TOWN OF YARMOUTH
200 Main Street, Yarmouth, Maine 04096
www.yarmouth.me.us

Planning Board Report
49-51 Bridge Street
Concept Major Site Plan, Major Subdivision, and Shoreland Permit
Mill Point at Yarmouth, LLC, Applicant
Map 33 Lot 8-00A; Village III District
Prepared by Erin Zwirko, Director of Planning and Development
Report Date: August 4, 2022; Planning Board Date: August 10, 2022

Subject Property is Outlined in Red

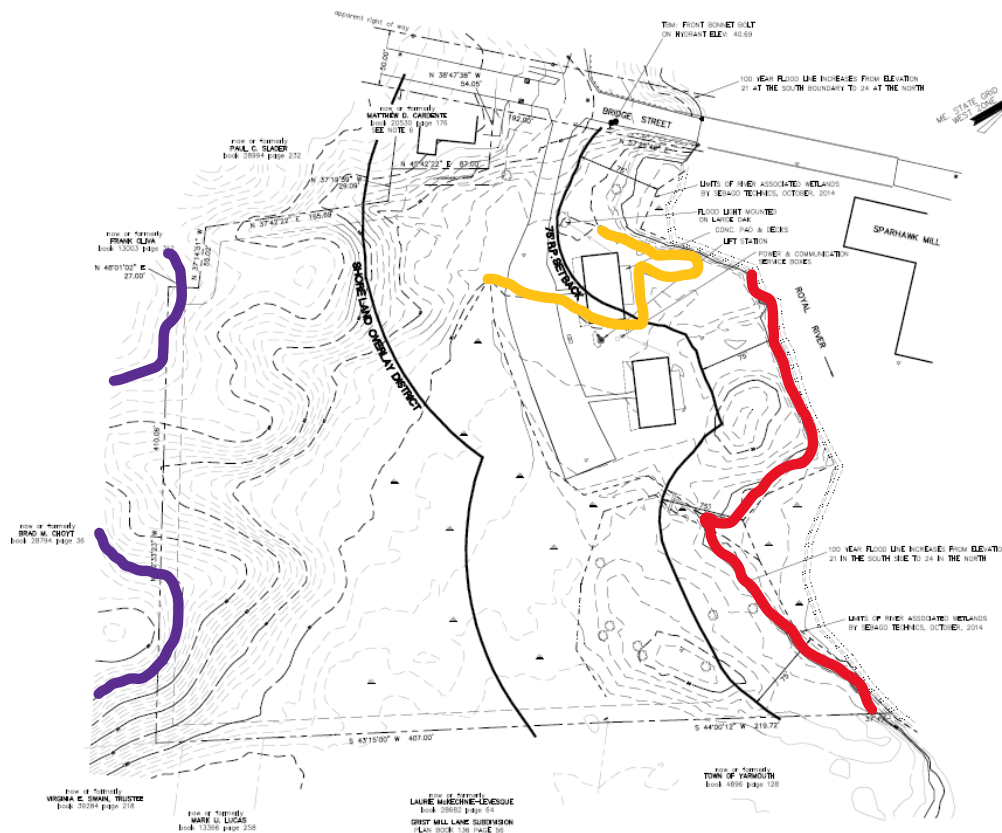
The property sits between Bridge Street and the Royal River, and at a significantly lower grade from Main Street located to the south.

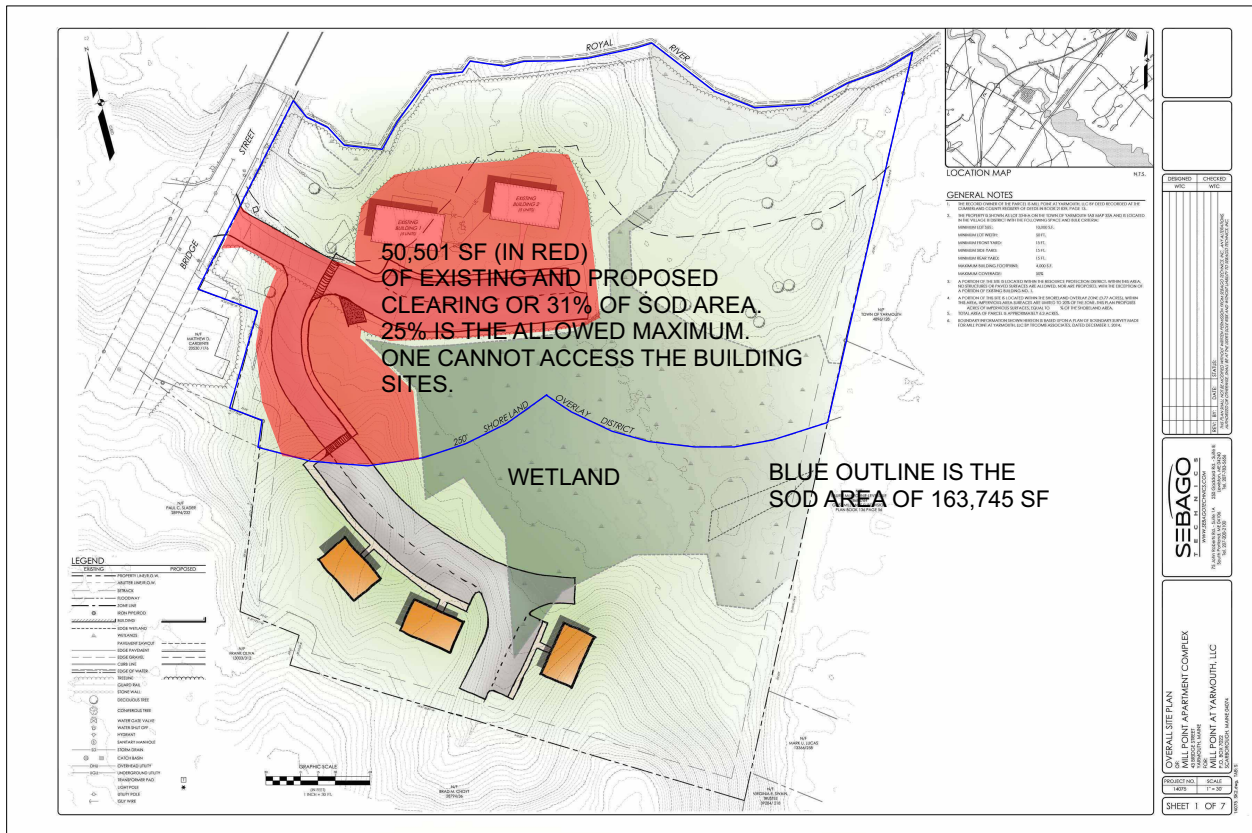
80% of the parcel to the south of the existing development is severely constrained by mapped wetlands, intermittent streams, and erodible 20% to 50% steep slopes. There are two relatively flat knolls to the far southern portion of the site, but these small areas are inaccessible, isolated, and undevelopable due to wetlands, steep slopes, and lack of street frontage. As stated by the Cumberland Country Soil Survey, in no uncertain terms, the only appropriate use for sites with the mapped soil type pf SuE2 is woodland. Developing a site for housing with such extensive mapped wetlands and mapped erodible soils is reckless, against code, and contrary to all environmental best practices for site development.

12. MILL POINT APARTMENTS

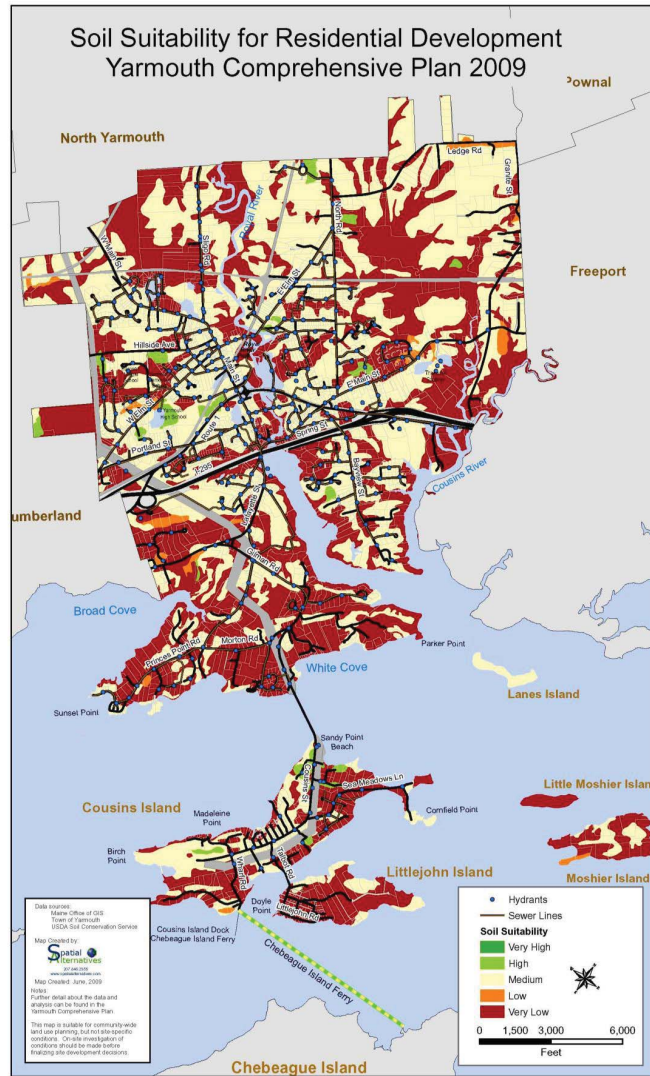
The Comprehensive Plan also includes a map called Soil Suitability for Residential Development and the project site is mapped as Very Low Suitability for Residential Development:
